PUBLIC NOTICE EXETER CONSERVATION COMMISSION

1. Review of a Wetland Waiver and Shoreland CUP from Palmer & Sicard Inc., for a 26,989 SF Office/Warehouse on Holland Way (Tax Map 66-1, Planning Board Case 18-22) (*Luke Hurley, GES Inc., Christian Smith, Beals Assoc.*)

Re: Site Plan Review TRC Comments
PB Case #18-22
Tax Map Parcel #66-1

REVISED PER ENG. REVIEW	2-20-19
REVISIONS:	DATE:
GRADING & DRAINAGE PLAN	
PLAN FOR: COMMERCIAL DEVELOPMENT HOLLAND WAY EXETER, NH	
DATE: DEC. 2018	SCALE: 1"=30'
PROJ. NO: NH-236.52	SHEET NO. 3 OF 9

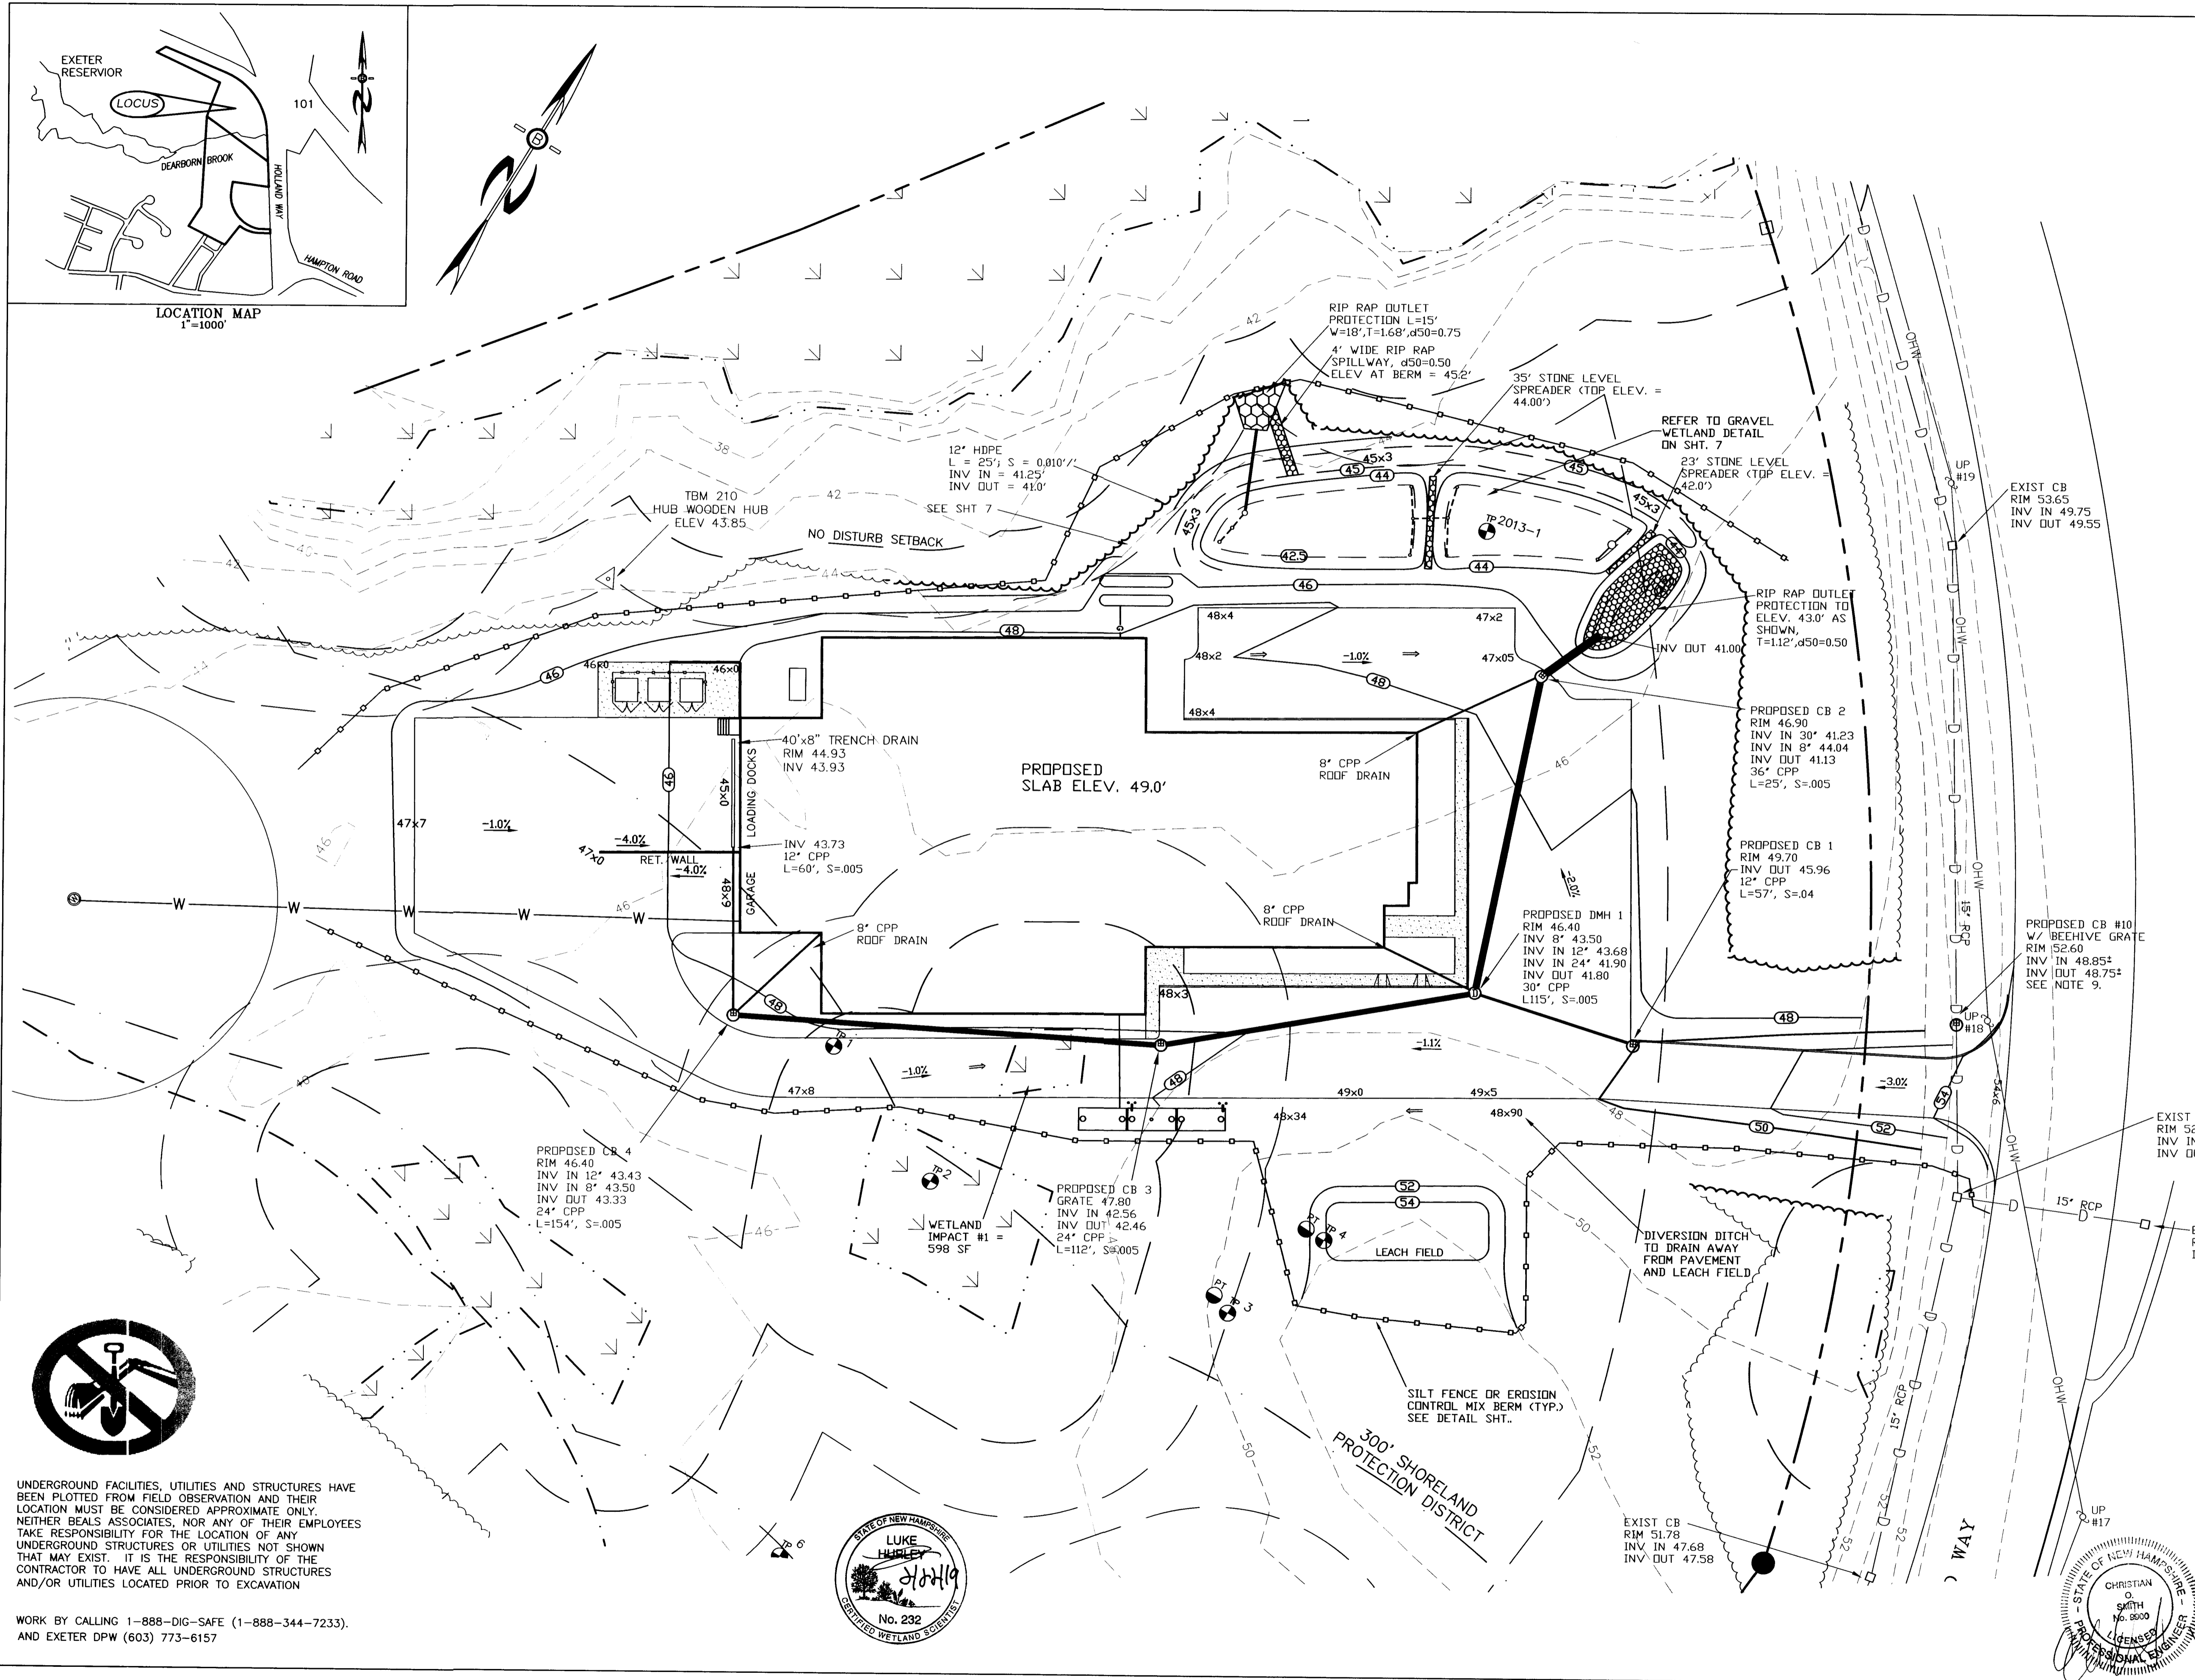
5. Sheet 3 of 9, Grading & Drainage Plan
 - a. Provide spot grades for the dumpster pad. **Response: Spot grades have been added as requested.**
 - b. Show the proposed tree limits, propane tanks, and well. **Response: All requested items have been added.**

- c. Existing topography is difficult to read. **Response: We apologize for the poor print quality and have provided better plan prints.**
 - d. The proposed outfall for the gravel wetland should be adjusted to not face the toe of the slope. This can be adjusted when the gravel wetland location is shifted to the east as discussed at the TRC meeting. **Response: The outfall has been revised as discussed.**

DATE: DEC. 2018	SCALE: 1"=30'
PROJ. NO: NH-236.52	SHEET NO. 4 OF 9

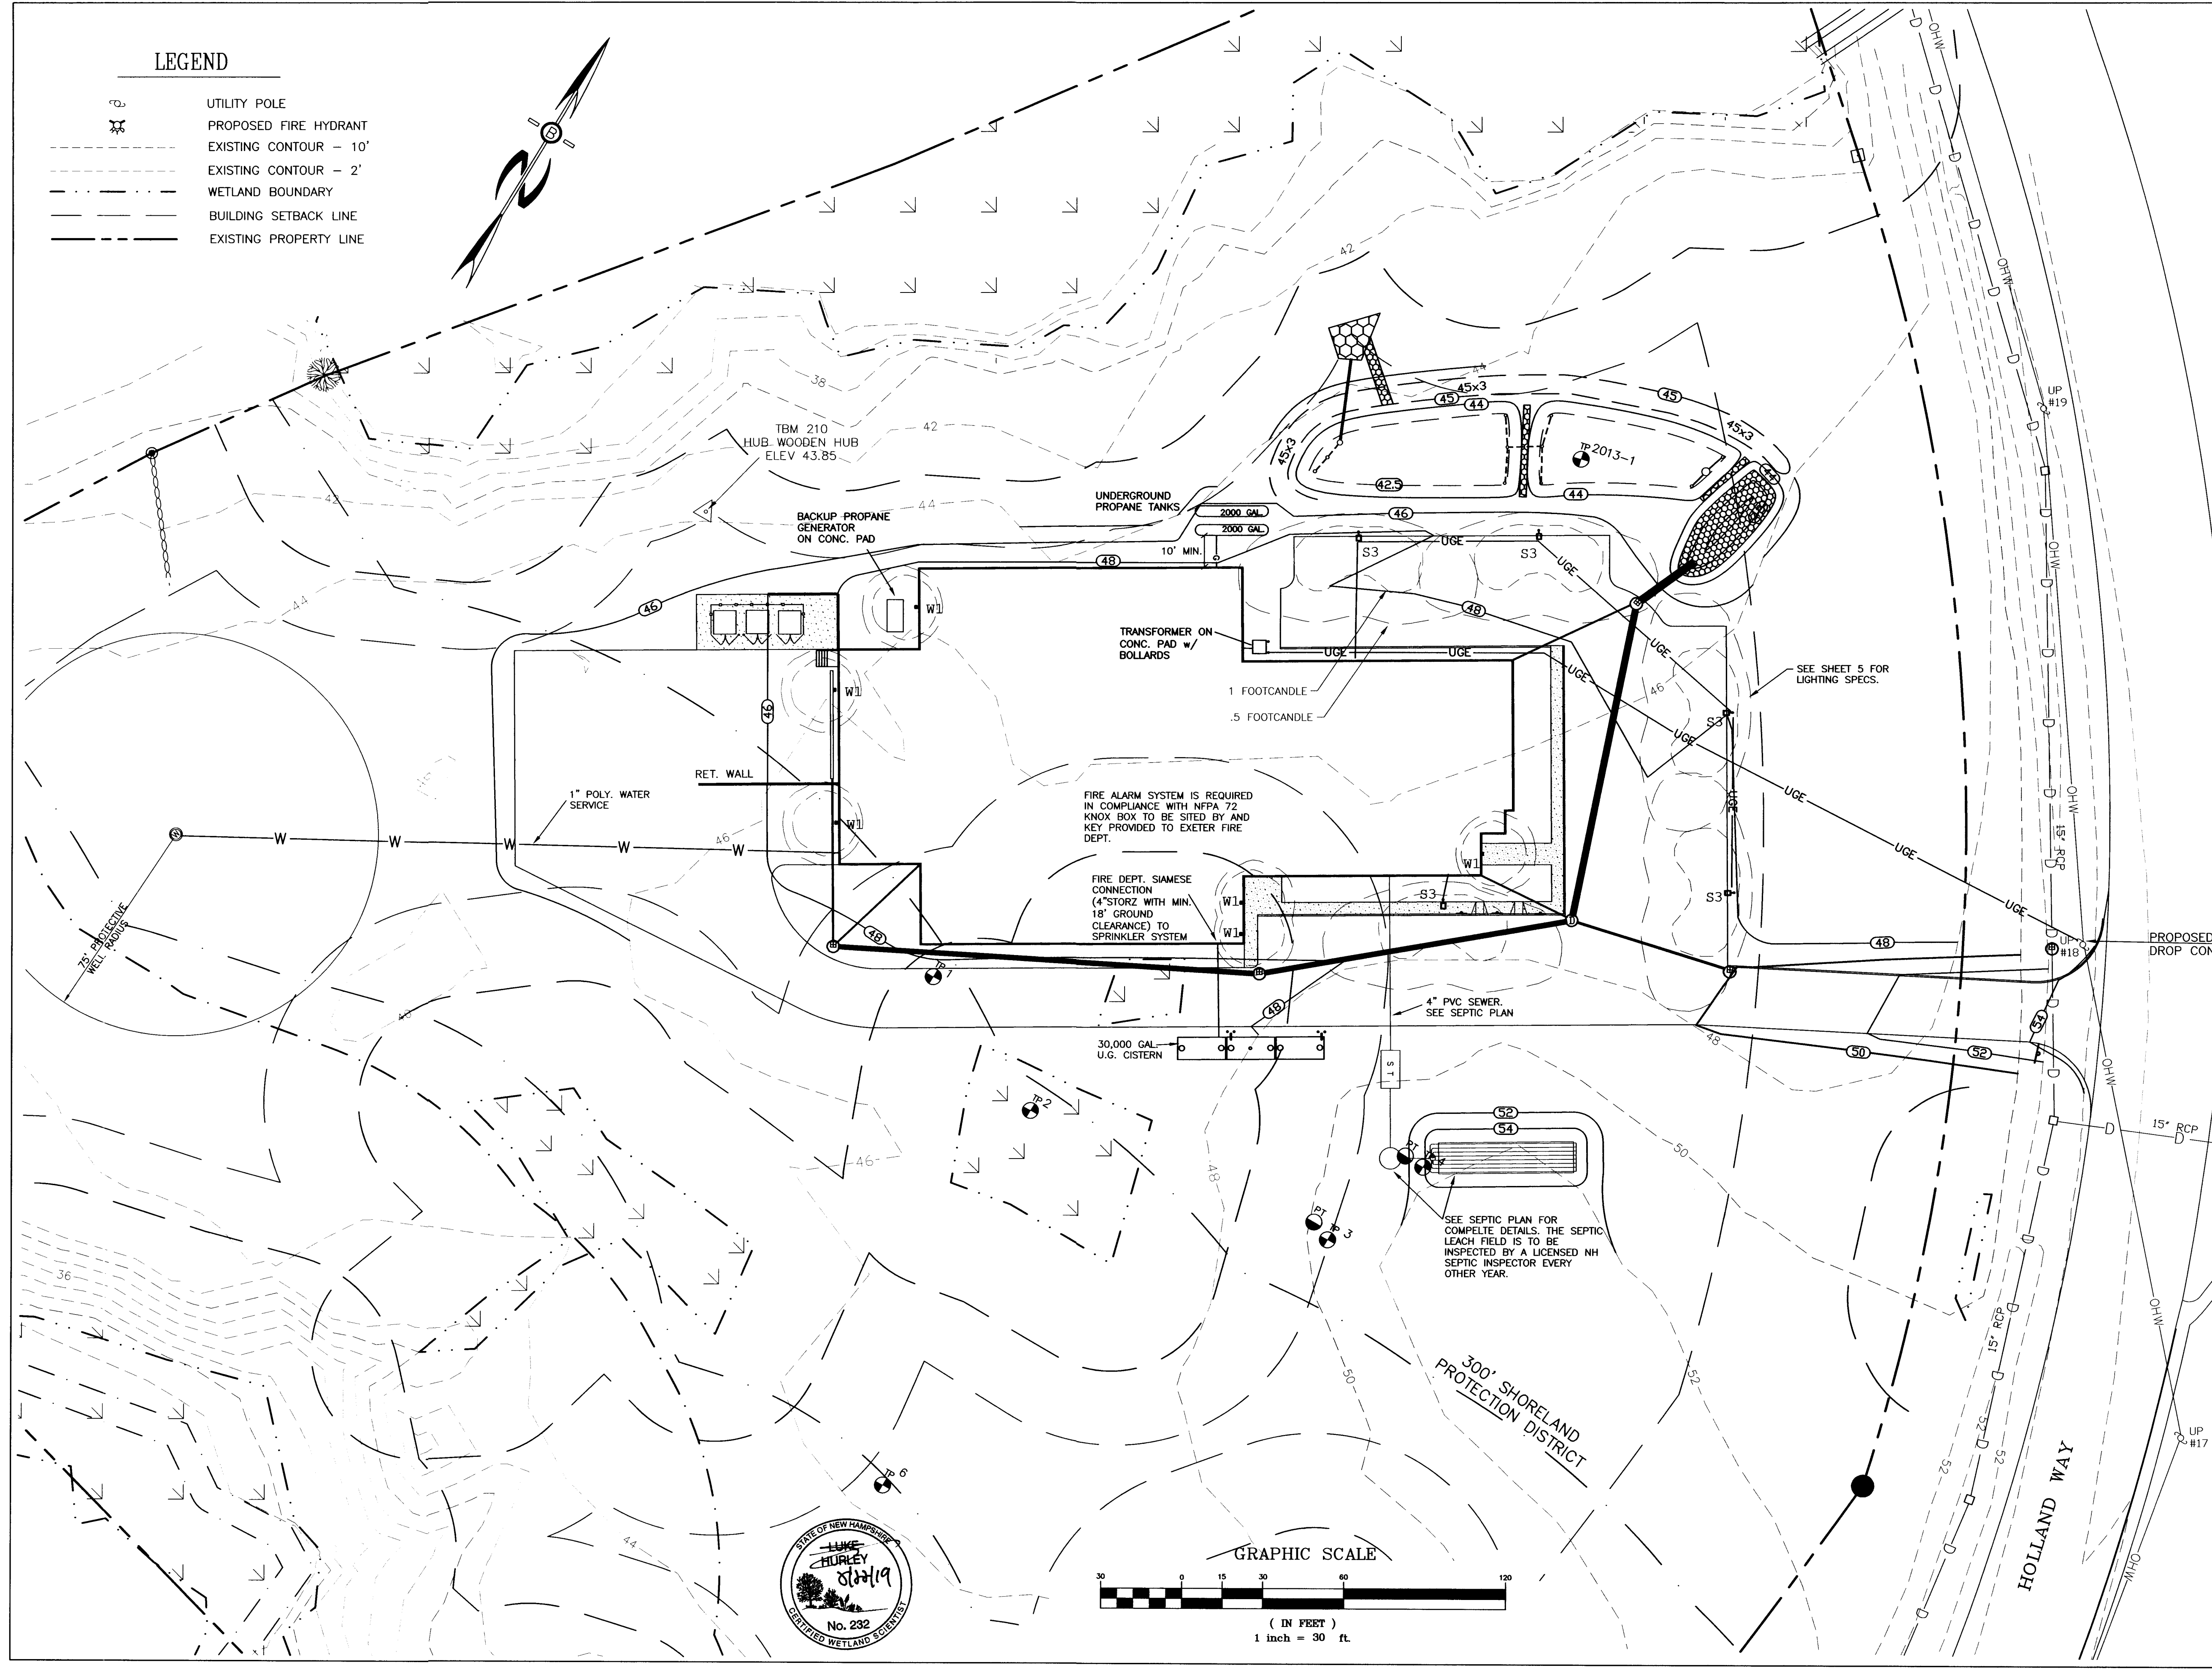
6. Sheet 4 of 9, Utility Plan
 - a. Identify if the generator will be diesel or propane. Diesel will require secondary containment. **Response: The generator will be fueled by the propane tanks.**

- b. The cistern should be a minimum of 10 feet from any part of the septic system. **Response: The cistern is shown approximately 20' from proposed septic system.**

- c. Confirm the propane tanks are the required minimum distance from the building and transformer. **Response: The transformer has been relocated and a setback distance added to the plans for the propane tanks.**

- d. A new utility pole may be required outside of the ROW. Coordinate with Unitil for drop pole location. Gas and electric layouts approved by Unitil are required for the final plans. **Response: The contractor is required to coordinate with all utility companies prior to construction.**
